Subject Addendum to 2015 Barrier Wall Groundwater Monitoring Plan Update

Project Name Tyco Fire Products LP, Marinette, Wisconsin

Date June 2019

Document Control No. 704683CH.264

**FIGURE 2-1 (ADDENDUM UPDATE)
PROPOSED GROUNDWATER ELEVATION
AND TOTAL ARSENIC MONITORING WELLS**

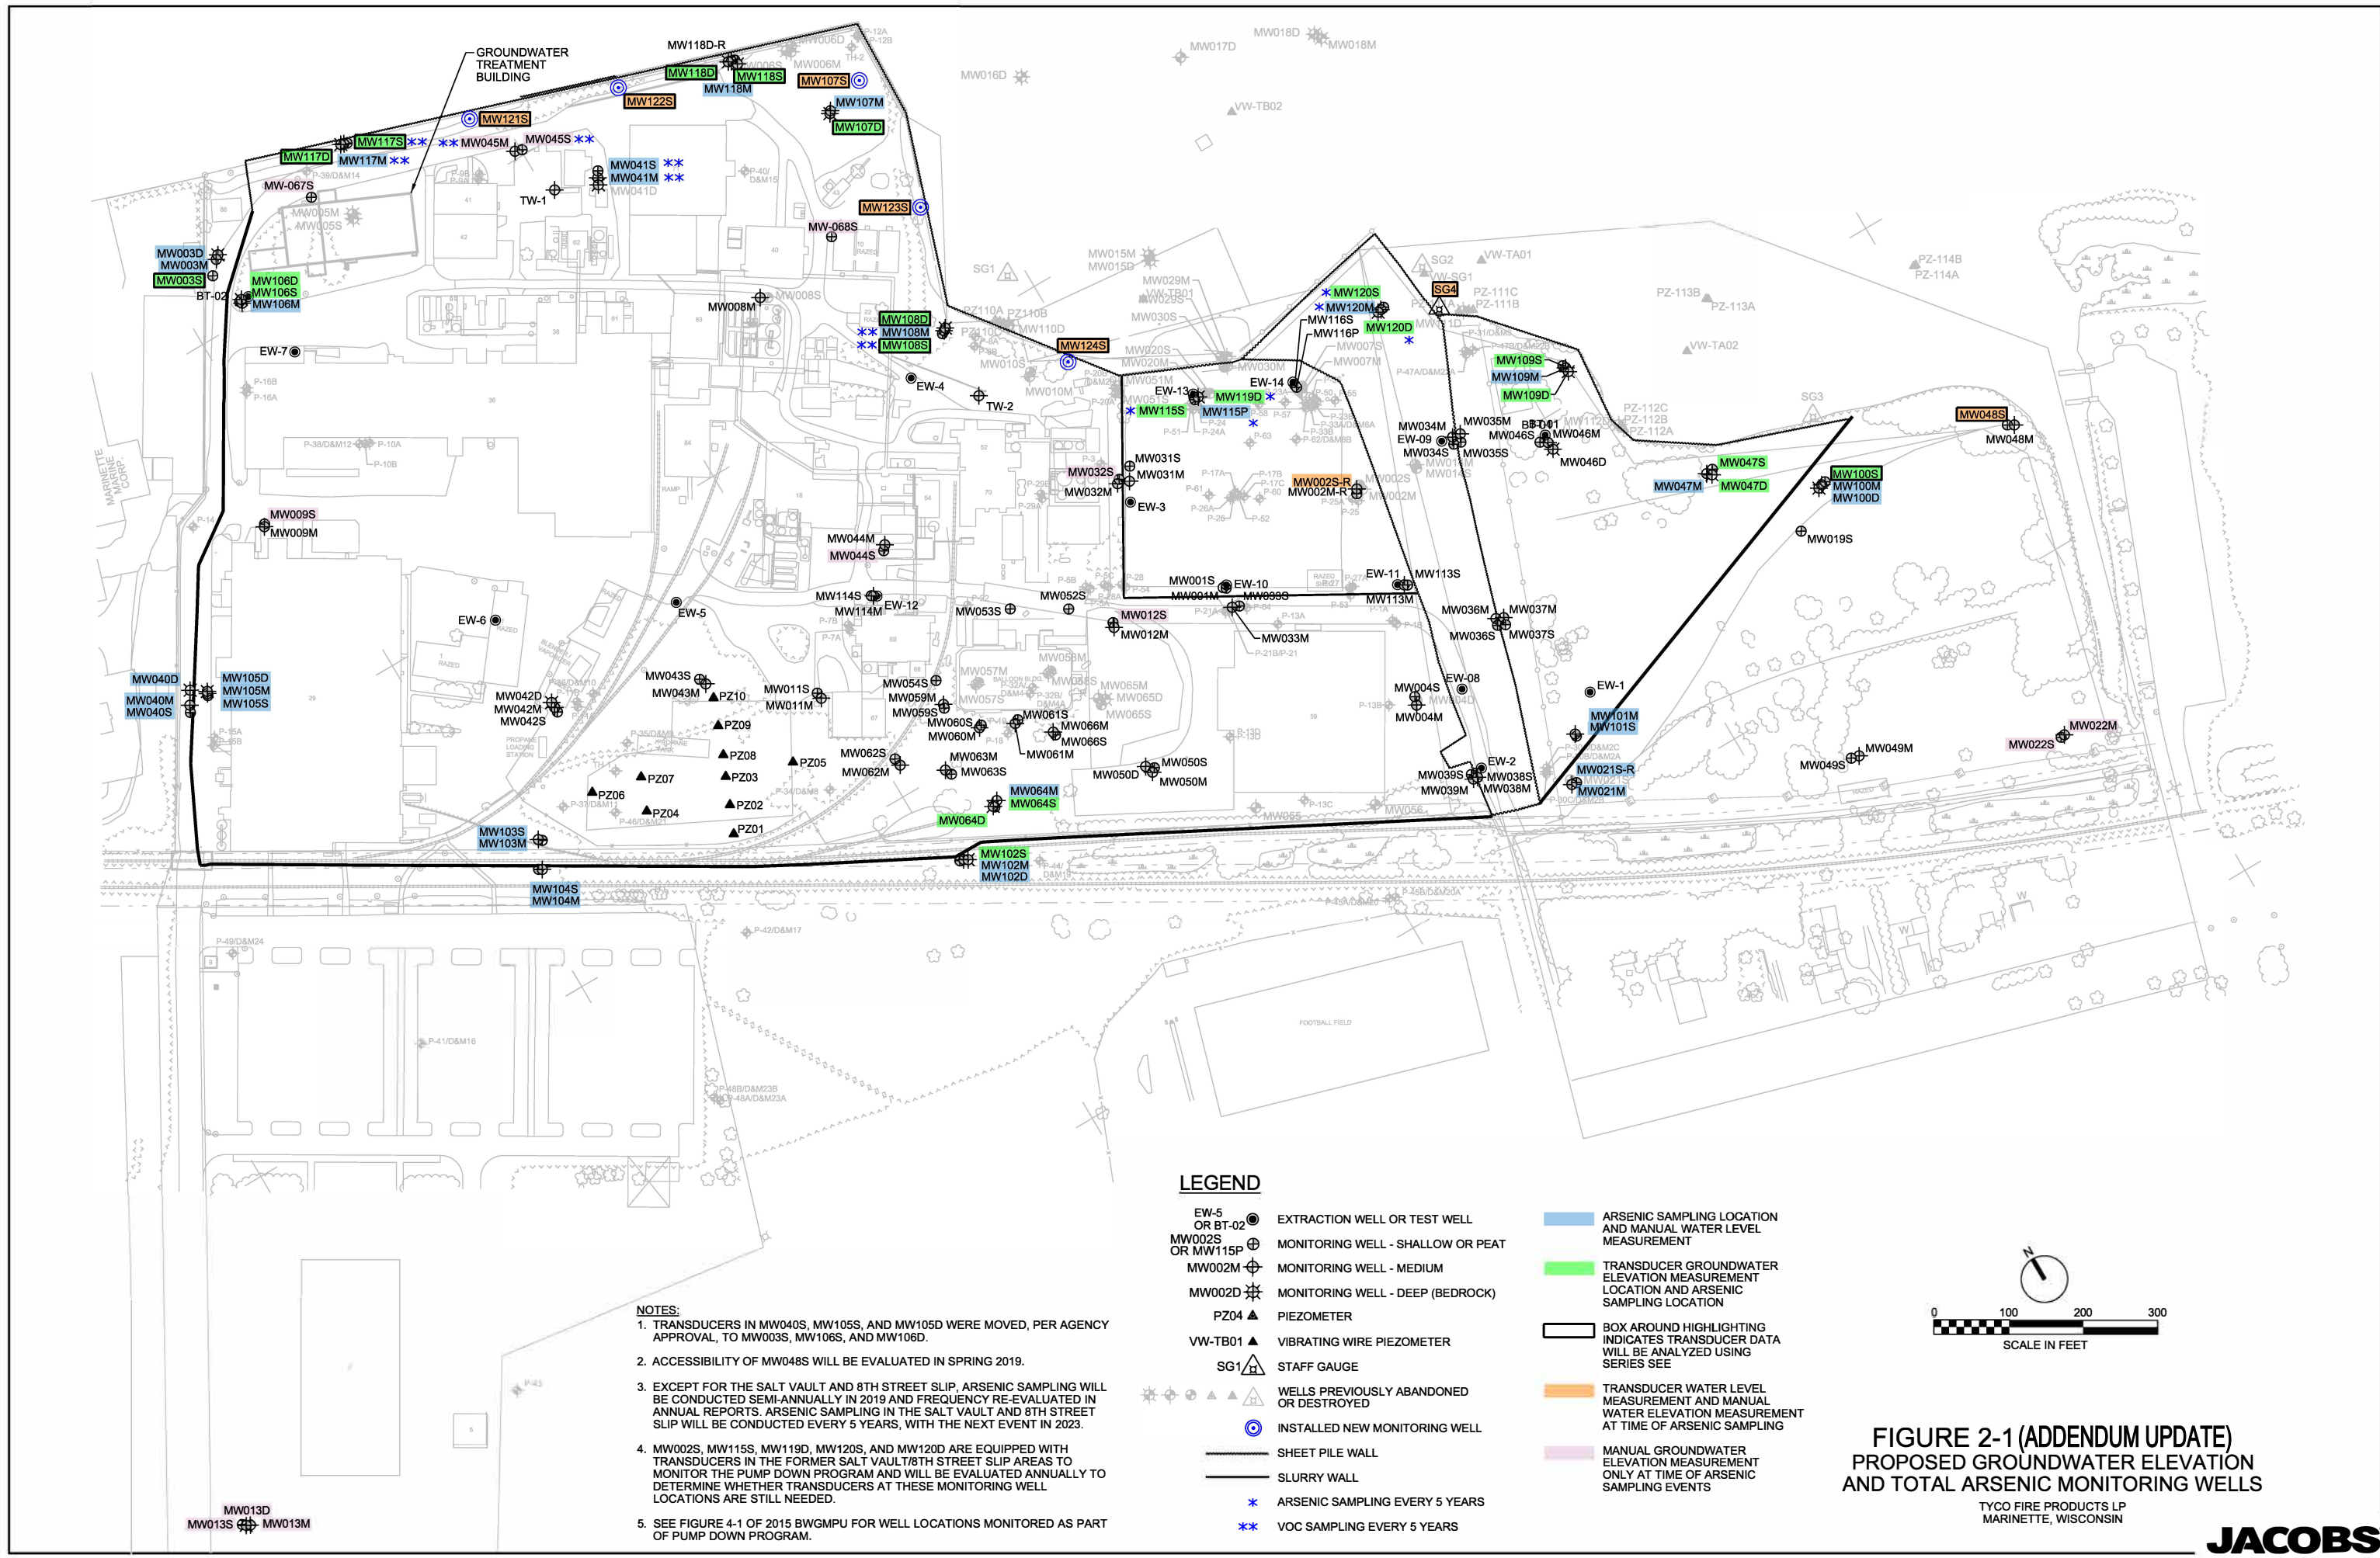
Five new shallow monitoring wells (MW107S, MW121S, MW122S, MW123S, and MW124S) were installed in June 2019 in the Main Plant to provide a monitoring well network along the VBW near the Menominee River with approximately 200-foot (or better) spacing.¹ Such spacing means that a monitoring well will be within 100 feet of a potential Main Plant VBW leak.² New monitoring well installation locations are shown on updated Figure 2-1; well spacing ranges from 160 to 200 feet between wells. Well installation, development, and surveying methods are described in the Monitoring Well Construction, Well Development, and Site Surveying portions of BWGMPU Section 2.2.3 and will be reported in the next annual report. Monitoring wells were installed within approximately 10 to 15 feet of the VBW.

- River stream gage (SG-4) to monitor river level fluctuations
- Two shallow monitoring wells in the Wetlands Area (MW047S and MW109S)
- Eight shallow monitoring wells in the Main Plant located adjacent to the VBW (MW108S, MW117S, MW118S and new wells **MW107S, MW121S, MW122S, MW123S, and MW124S**)

Table 2-1 and Figure 2-1 from the 2015 BWGMPU have been updated to reflect the new well locations, manual groundwater elevation monitoring wells, and updated pressure transducer locations.

Figure 2-4. Vertical Barrier Wall Technical Evaluations Flow Chart
Tyco Fire Products LP Facility, Marinette, WI

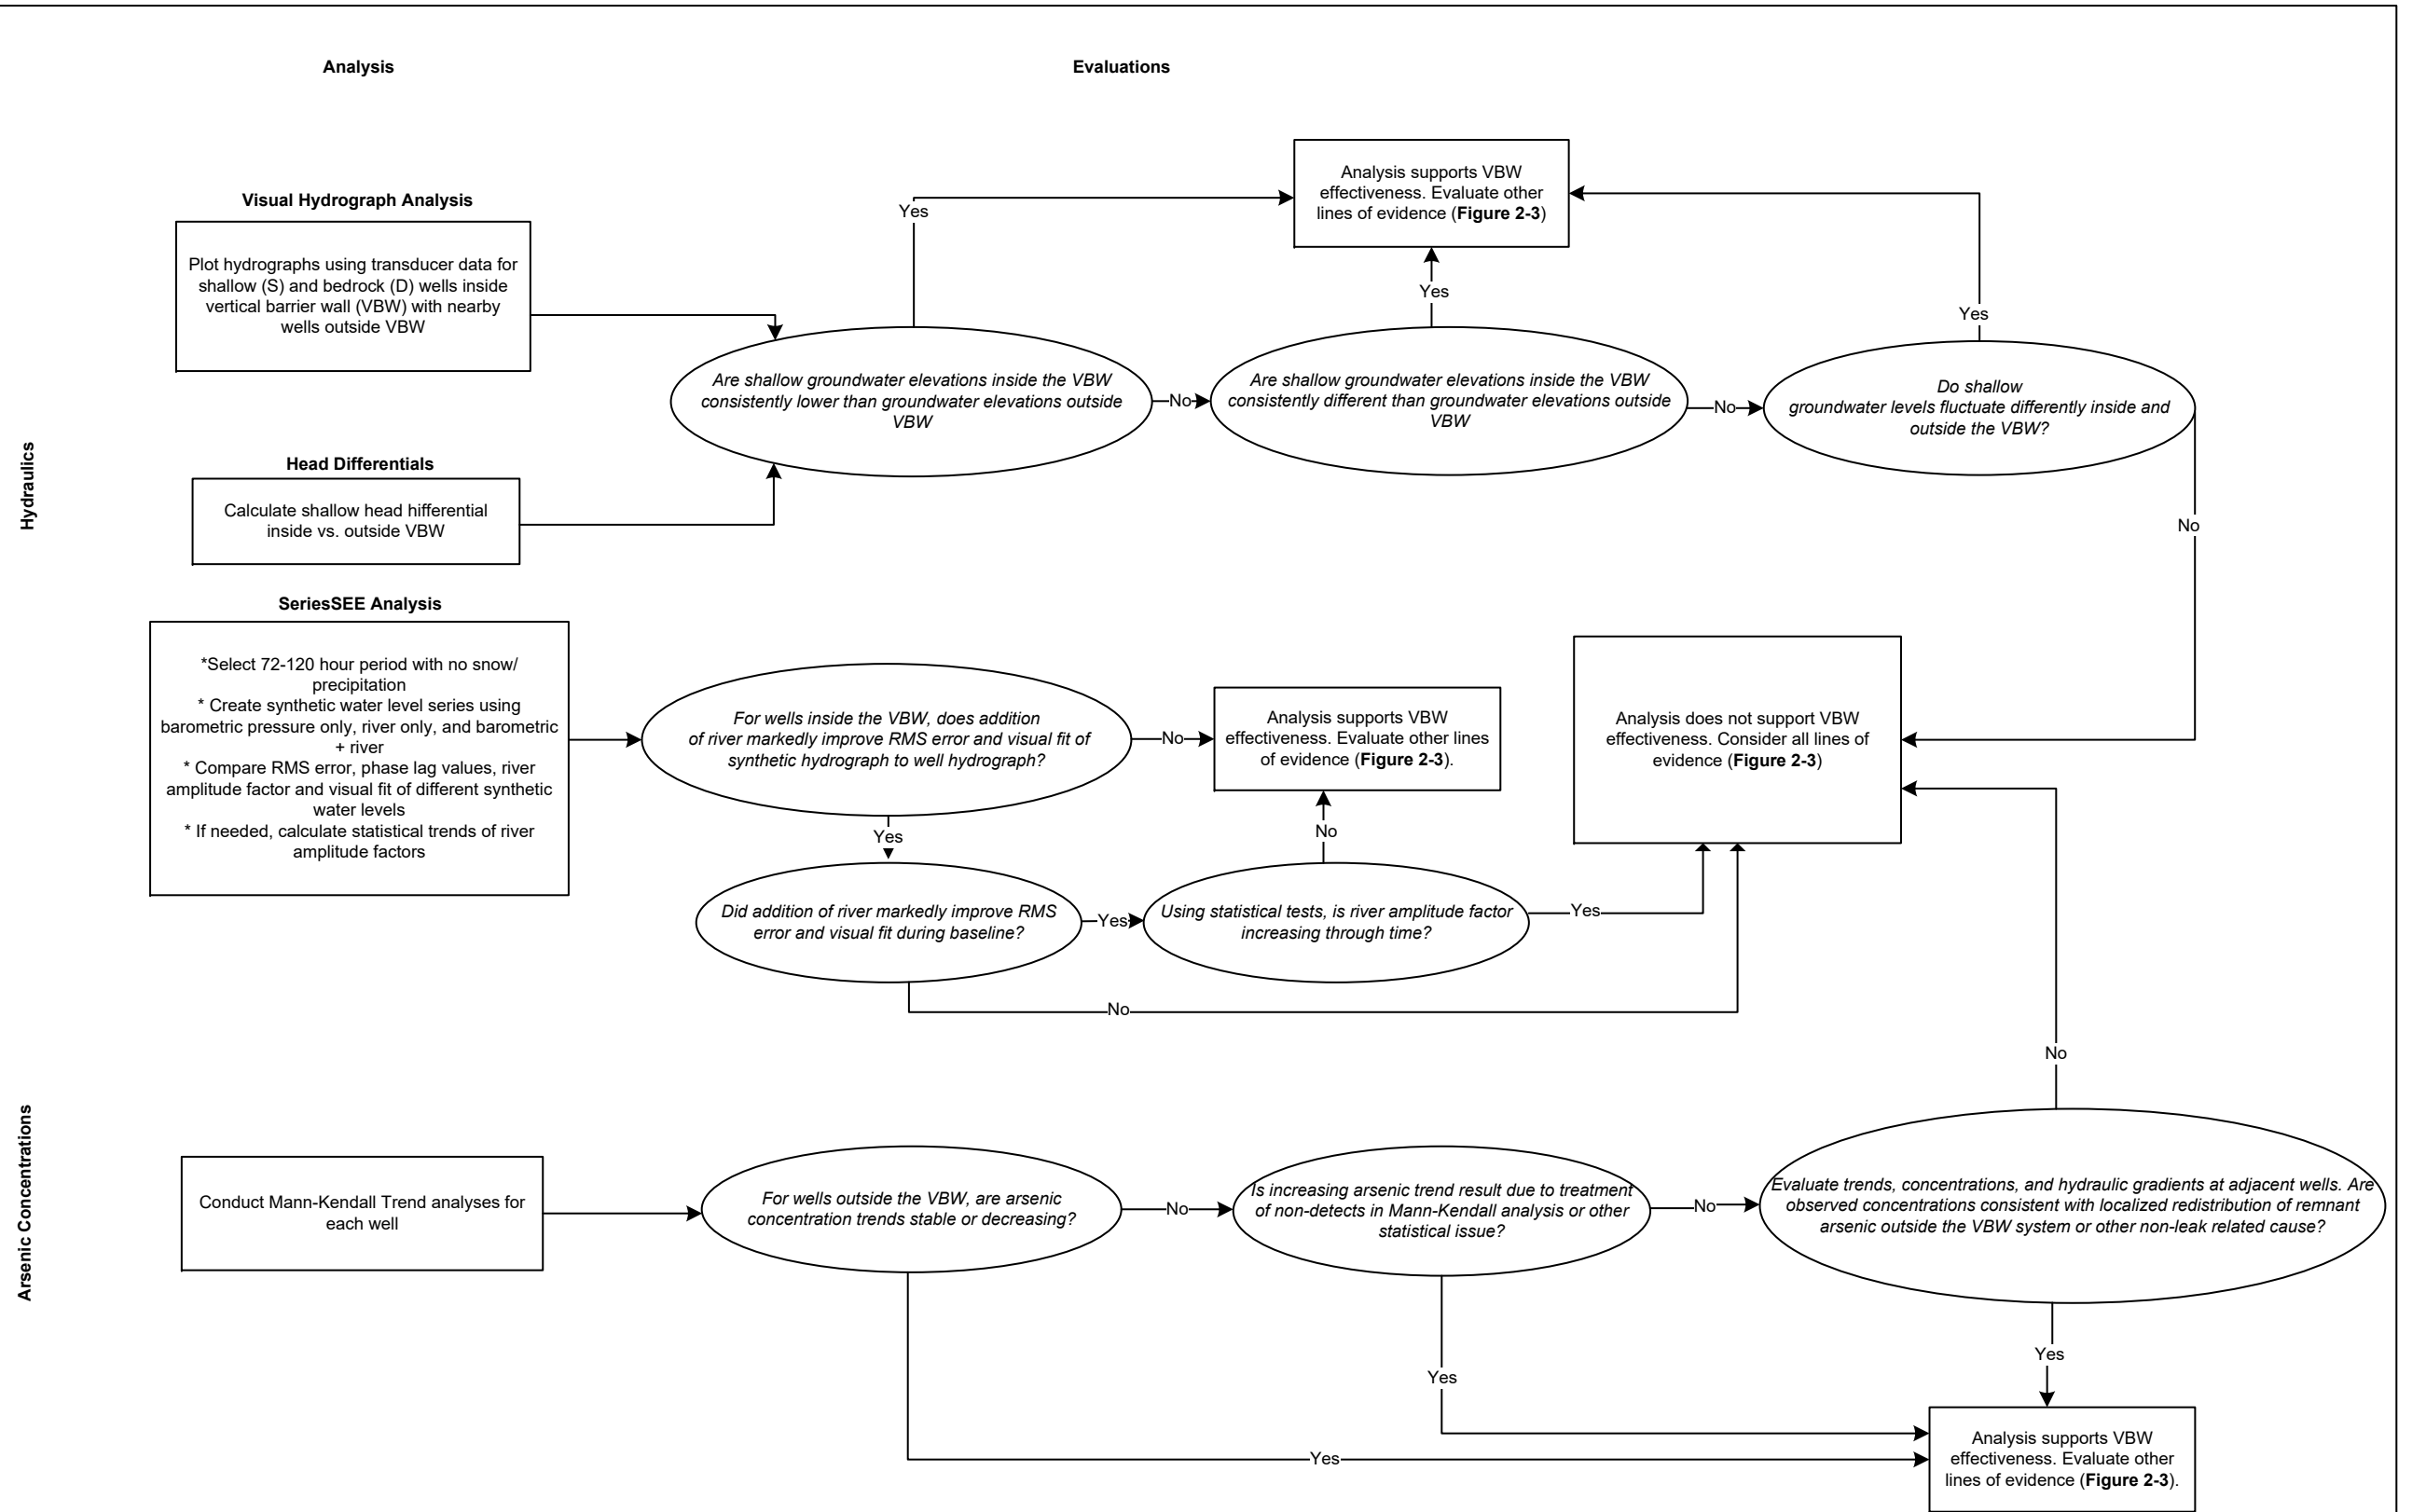
A new decision tree figure summarizing evaluation steps for each line of evidence, including the new SeriesSEE evaluation, is provided on new Figure 2-4.

- Visual inspections and surveys above the waterline, as described in the BWGMPU
- Visual inspection below the waterline, as described in this addendum
- Groundwater elevation monitoring results, including:
 - Groundwater head differential comparisons inside/outside VBW (as described in BWGMPU Section 2.2.5 and summarized on new Figure 2-4)
 - Groundwater contour maps for shallow and deep monitoring wells (as described in BWGMPU Section 2.2.5) but may be dropped in the future if SeriesSEE and VBW underwater inspection are deemed sufficient to evaluate VBW effectiveness
 - Visual comparison of transducer hydrographs for wells distant from the river (as described in BWGMPU Section 2.2.5 and summarized on new Figure 2-4).
 - The new SeriesSEE transducer analysis for select Main Plant wells adjacent to the river (summarized on new Figure 2-4)

- Groundwater arsenic monitoring, including temporal trend assessment, evaluation of hydraulic gradient direction and magnitude (if contour maps are produced), comparison of concentrations inside and outside wall, and evaluation of localized redistribution of arsenic outside VBW (as updated on new Figure 2-4)¹³
